REMARKS

In response to the Office Action mailed September 14, 2005, Applicants respectfully request reconsideration.

Title: DSL TRANSMISSION SYSTEM WITH MEANS FOR
ENSURING LOCAL ECHO ORTHOGONALITY
Inventor: Isso et al.
Serial No.: 09/517,417
Docket No.: S1022.80316US00
Sheet 4 of 4
ANNOTATED SHEET SHOWING CHANGES

Fig 4

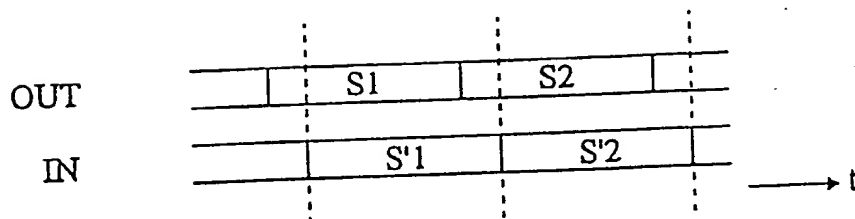
In response to the objections to the text on page 2, lines 23-30, and the objections to the drawings, Applicants have amended Figs. 5, 6 and 8 to alleviate any confusion between use of the term "Sample" and "Symbol." Further, as the amendments to the drawings should further clarify, the dotted lines in Fig. 4 are not representative of the precise point at which a sampling takes place, but rather indicate the boundaries in the time domain between samplings of incoming symbols and outgoing symbols.

Fig. 4 illustrates symbols being transmitted and received in the *time domain*. “For clarity reasons, it is supposed that the incoming symbols convey only one sub-carrier f_1 and the outgoing symbols convey only one sub-carrier f_2 , the sub-carriers f_1 and f_2 being adjacent.” (Page 2, lines 24-26 as amended by this Amendment). In other words, for illustrative purposes, it is supposed that incoming symbols $S'1$ and $S'2$ are composed of only one sub-carrier f_1 , and outgoing symbols $S1$ and $S2$ are composed of only a single sub-carrier f_2 .

As is clearly illustrated in Fig. 4, during the sampling of incoming signal $S'1$, a transition occurs between outgoing symbols $S1$ and $S2$. Accordingly, during the sampling of symbol $S'1$, the *echo* of the transition between the outgoing symbols $S1$ and $S2$ is also sampled. (See page 2, line 26 – page 3, line 2). “Such transitions are discontinuities which have a wide spectrum in the frequency domain. This is shown in figure 3 by dotted lines for sub-carrier f_2 . This wide spectrum effects all the nearby channels.” (Page 3, lines 2-6). Thus, Fig. 3 illustrates that, at the time of the transition between $S1$ and $S2$ in the echo of the outgoing symbol, the discontinuity of the transition causes a wide spectrum, which is illustrated by the dotted lines of sub-carrier f_2 in Fig. 3. The wide spectrum of the discontinuity interferes with the sampling of the symbol $S'1$ on sub-carrier f_1 , which is adjacent to subcarrier f_2 .

Fig 5

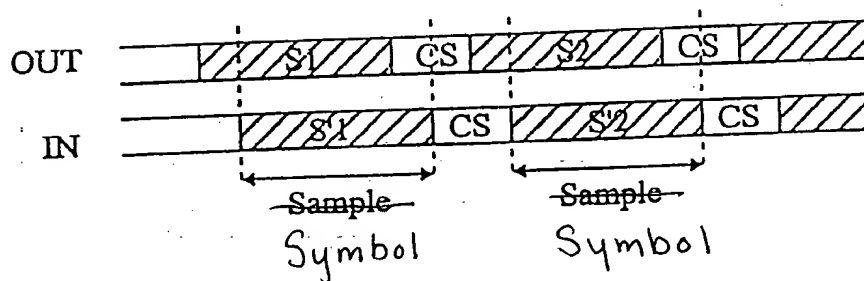
In response to the objections to the drawings (Section 2), Applicants submit herewith Annotated drawings showing the amendments to Figs. 5, 6 and 8, and Replacement Drawings showing Figs. 5, 6 and 8 as amended. Applicants have replaced all occurrences of the term “Sample” with the term “Symbol” in these drawings to be consistent with the specification. No new matter has been added by these changes.

Fig 6

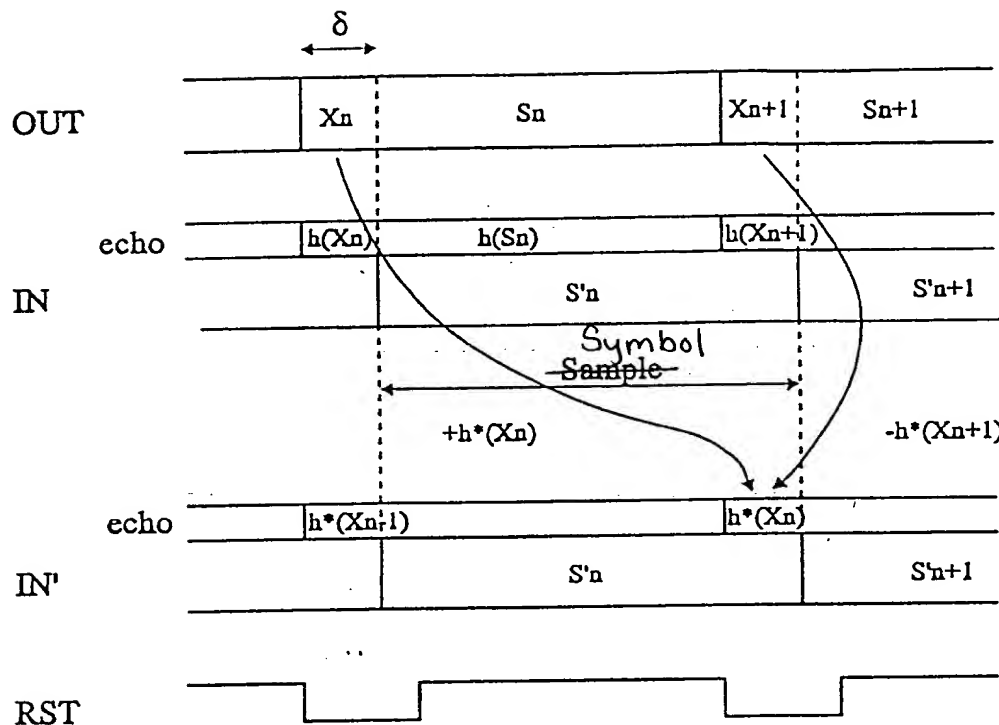
By removing the echo portion and replacing it with a portion from the beginning of the echo symbol S_n , the transition between $h(S_n)$ and $h(X_{n+1})$ of symbol IN illustrated in Fig. 6 is

removed. Removing the transition removes the discontinuity that has the wide spectrum that would otherwise cause interference with nearby sub-carriers of an incoming signal, as described in Applicants' specification with respect to sub-carriers f1 and f2 in relation to Figs. 3 and 4, and as further explained above.
